## ANN ARBOR HISTORIC DISTRICT COMMISSION

### Staff Report

**ADDRESS:** 711 West Jefferson Street, Application Number HDC21-223

**DISTRICT:** Old West Side Historic District

FRONT (NORTH) ELEVATION

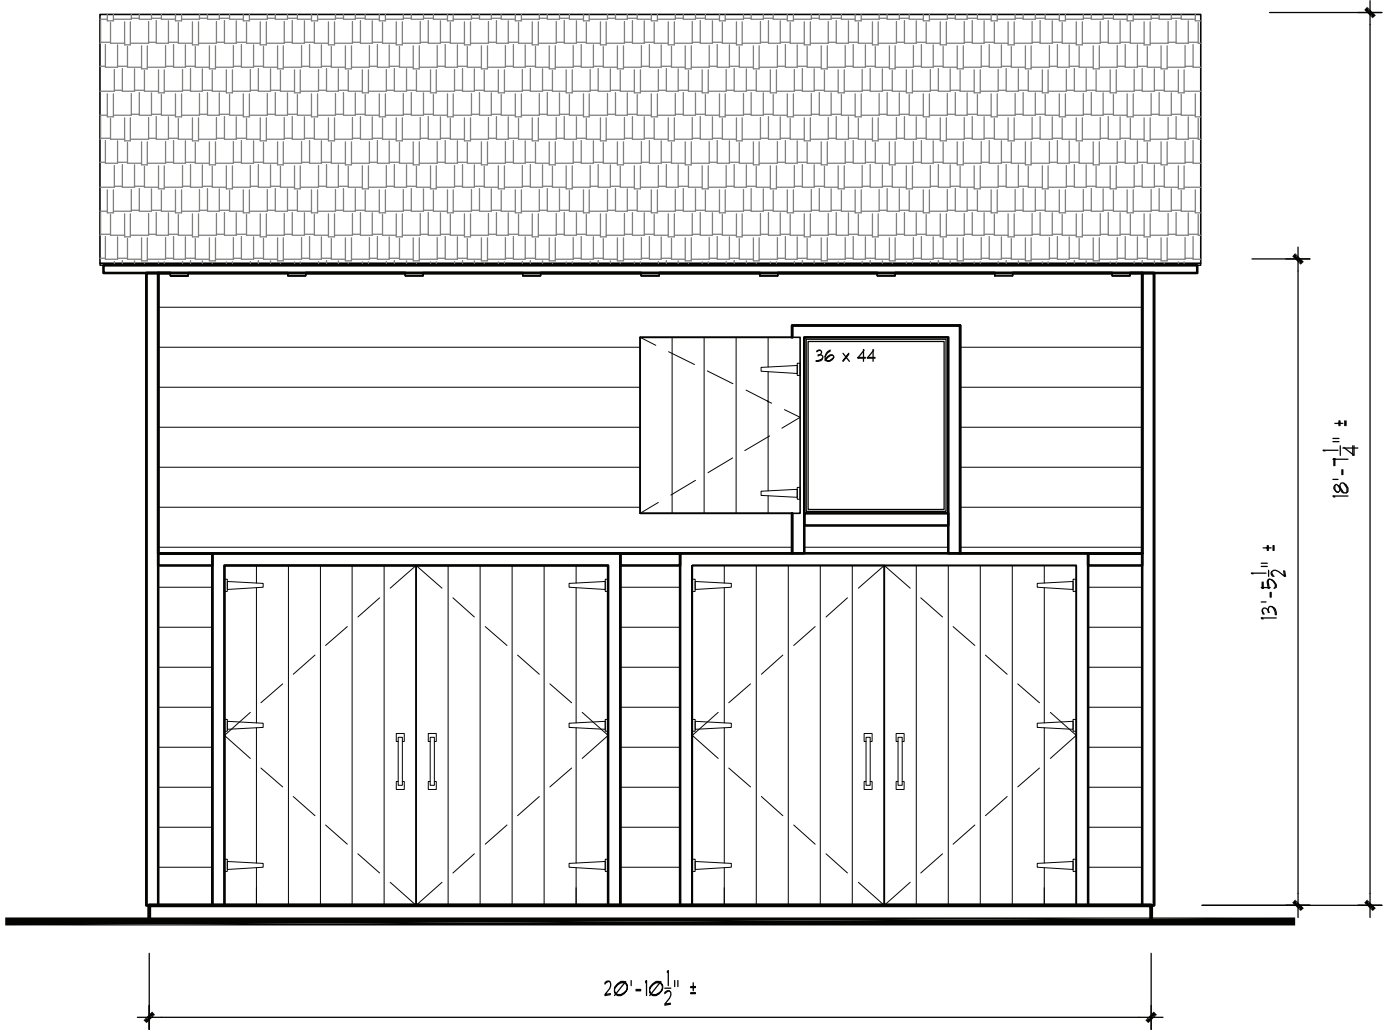
1. Staff has requested additional and updated drawings, including existing elevations; dimensions of the building, windows, and doors; window and door materials and dimensions and window profiles; whether the fascia on the front elevation is original or added to hold the gutter; etc. If this information is received in time, commissioners will be notified, and the attachments will be updated.
2. *North Elevation.* On the front elevation, the two pairs of double-leaf doors remain. The hay door on the upper floor would remain, but the opening infilled with a piece of fixed

glass. A new header is proposed above the double-leaf doors. This header causes an increase in the distance between the hay door and the leaf doors (staff believes the leaf doors are getting shorter, but this needs confirmation). This header area is proposed to have horizontal siding to match the existing.

The existing wood doors (5) will be reused as the outer doors for the large openings on the north elevation.

On the north elevation, a fascia board was added to the rafter tails to facilitate the addition of a gutter, sometime in the past. This was not added to the south elevation as there was no door to protect. There is little doubt this decision did however contribute to the rot on the bottom of the south wall. Given that we would like to provide a new entry door on the south wall we would also like to have gutters there. However we can accommodate the gutter without needing a fascia board.

SIDE (WEST) ELEVATION

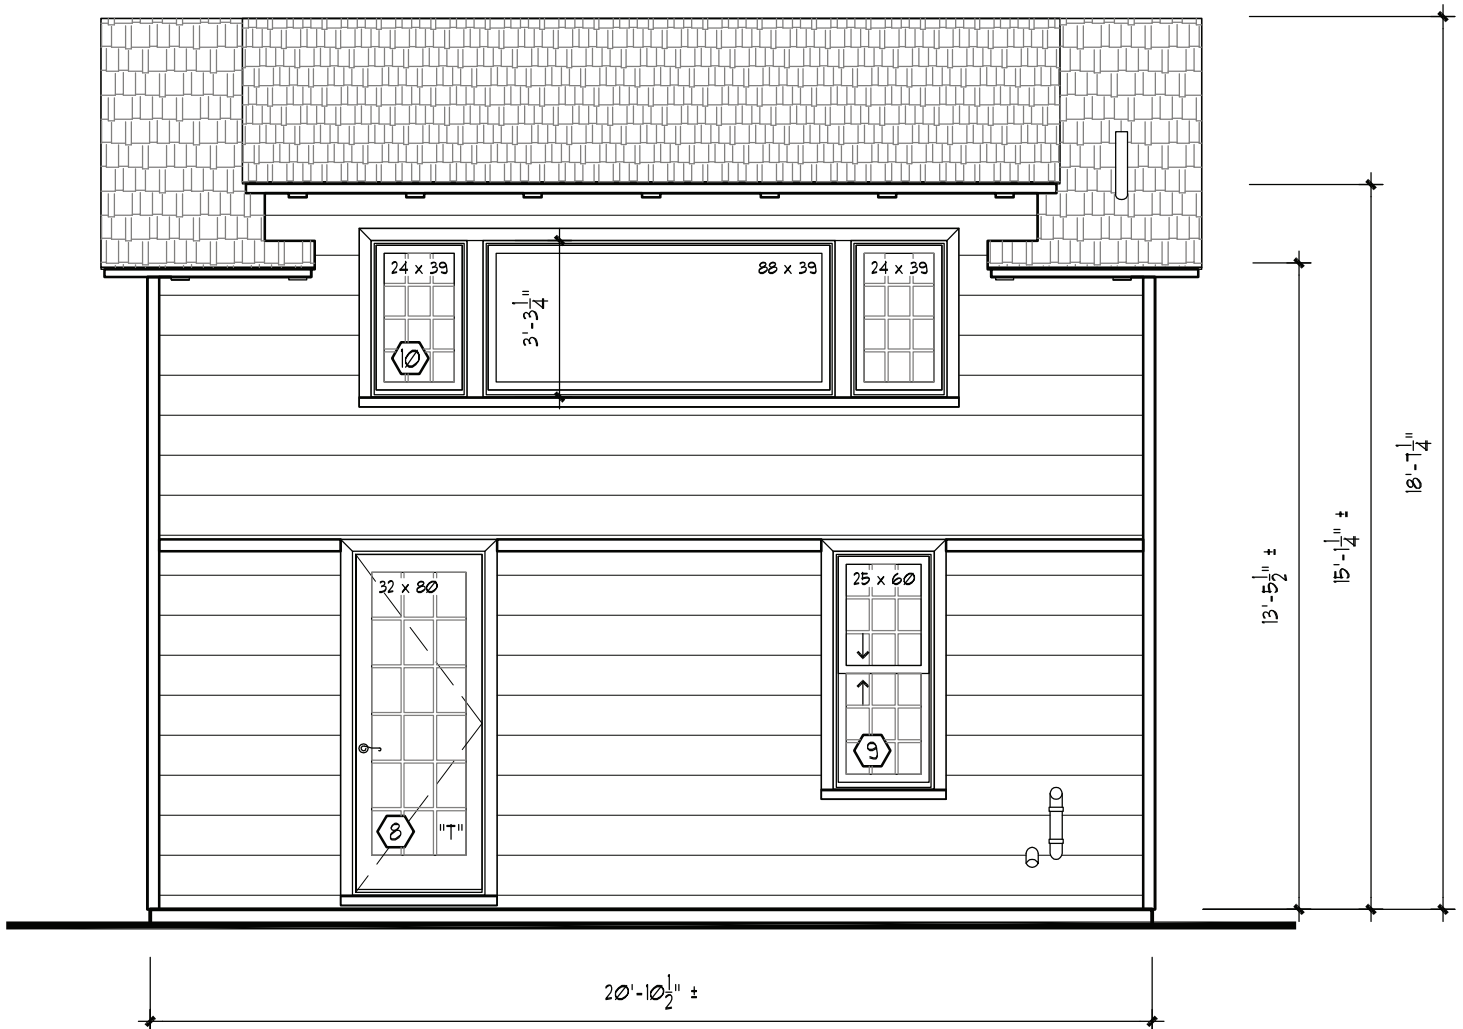
3. *West Elevation.* This elevation currently has a single six-lite window centered on each floor. They appear to be the same size. Proposed is a replacement six light window on the upper floor with four additional matching windows in a row beneath it. On the ground floor are two pairs of sliding doors with 24 lites each. This is the most radically changed of the elevations.

It is our observations that the west elevation had some kind of other wall finish on it in the past. The boards high up are bright wood; evident that they have not been exposed to the weather. There is also evidence that there had been corner boards. We decided it was most likely that that elevation matched the east elevation, having a horizontal board below the upper windows. Including this balances the building as it would be strange to have one but not the other.

REAR (SOUTH) ELEVATION

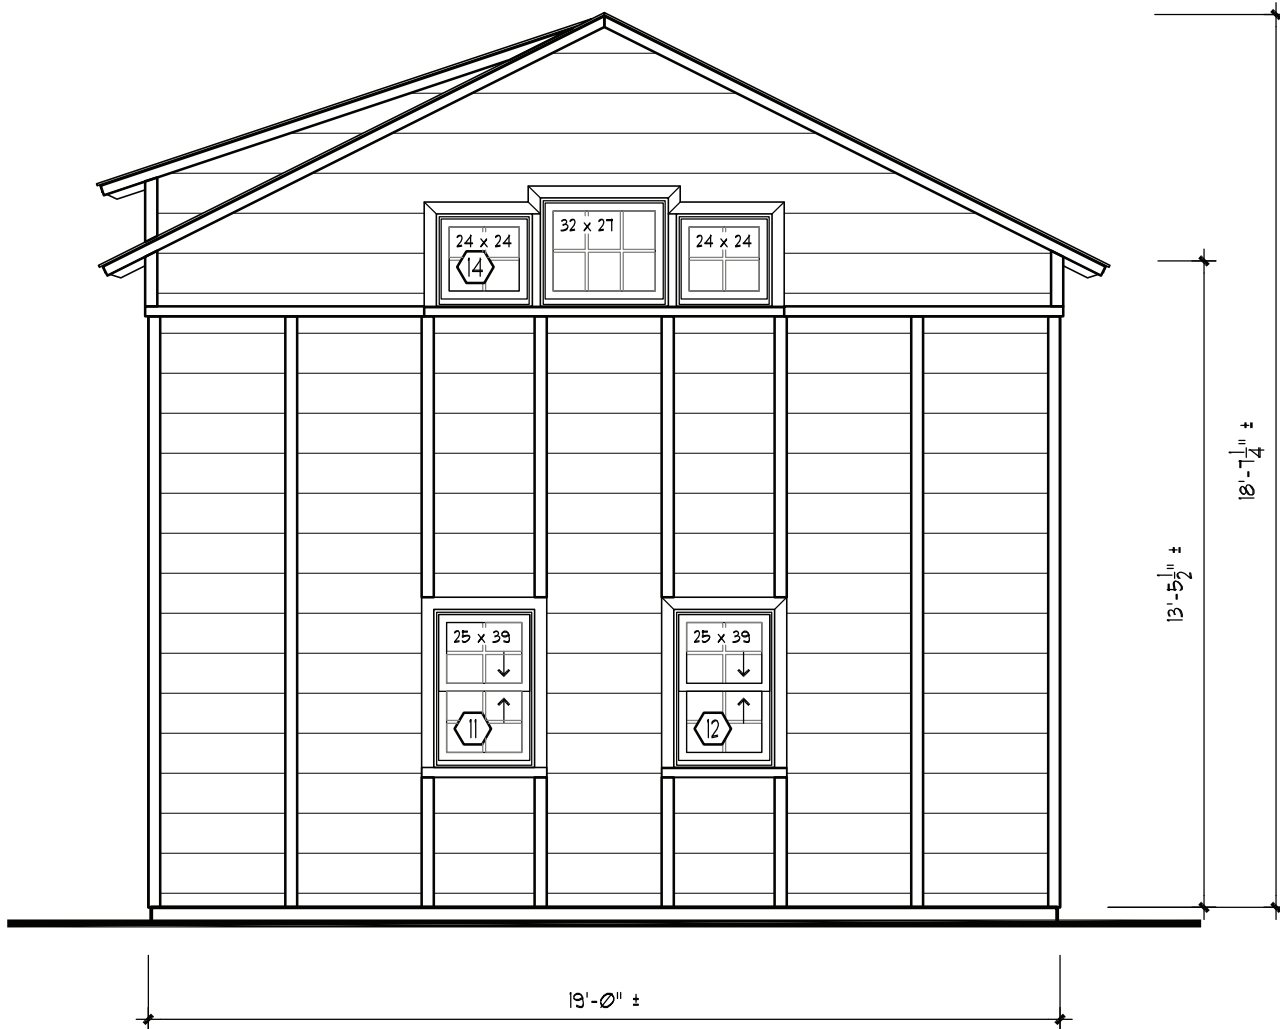
4. *South Elevation.* In the upper story, the dormer would be invisible from the street and would provide headroom in the upper story of the barn. On the first story, one existing 2/2 window appears to be replaced with a 9/9 and the other replaced by a door, though they could each be shifted outward slightly. When existing elevation drawings are received it will confirm whether the door and window are where the two windows are currently, or if they are each shifted.

There will be just a few vents required for the building. A vent through the roof will be needed on the south slope of the roof and a vent for the furnace will be needed through the south wall. Both are shown on the elevations.

SECTION DETAIL

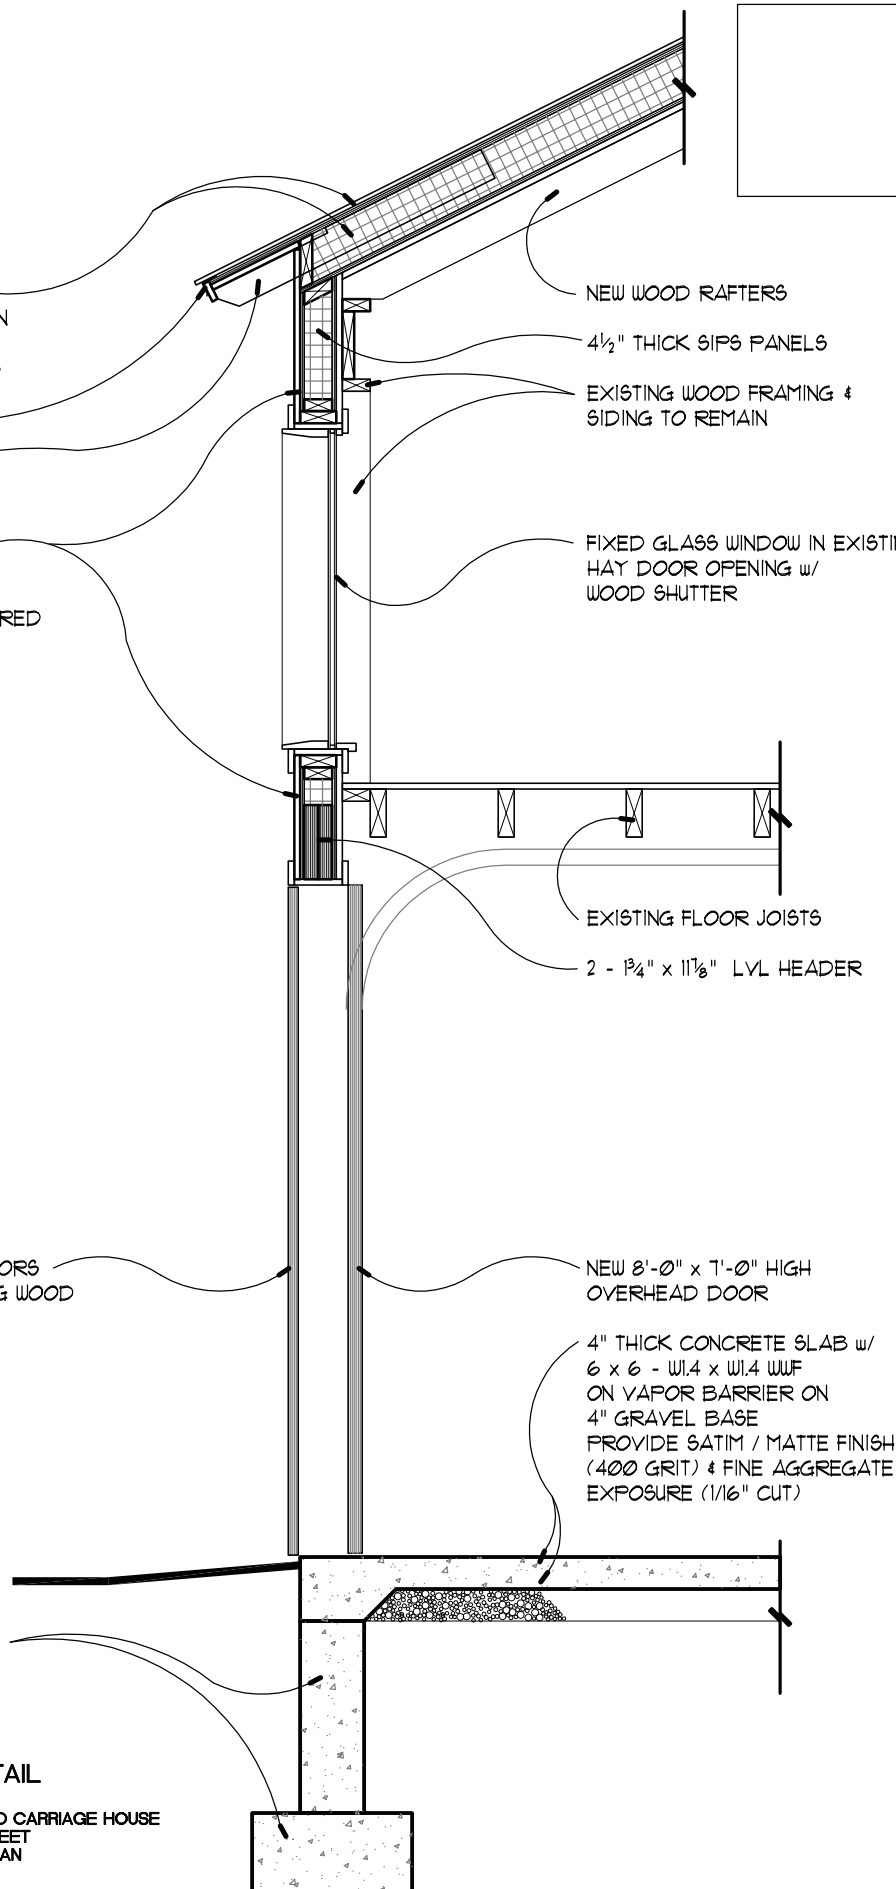
6. The section detail on sheet A-5 shows 4 1/2 " thick structural insulated panels (SIPs) attached to the existing siding and framing, with new horizontal wood siding on the exterior. The double-leaf doors have a note that they will be relocated (because of the added thickness of the walls from the SIPs) and that as much of the existing wood and hardware would be reused as possible.

7. The wide board siding is a character-defining feature of the barn, and staff has concerns that the siding width is not indicated on the application. Matching the existing dimension of the siding has been include in the possible motion below as a condition of approval.

Per the drawings, the existing building is to be clad with SIPS to ensure that all of the non-rotten parts of the building will be saved and continue to be a functioning part of this building. As stated earlier, we are aware that the roof's rafters are rotten, as is a portion of the roof boards. We will be replacing those with comparable materials. The holes in the roof have also taken a toll on the loft framing, which will also be replaced if structurally required. Other than that we do not expect there to be too much of the exterior walls that cannot remain. The SIPS are to be clad with 8 to 12 inch wide gray wood boards that will be very comparable to the siding that is there today.
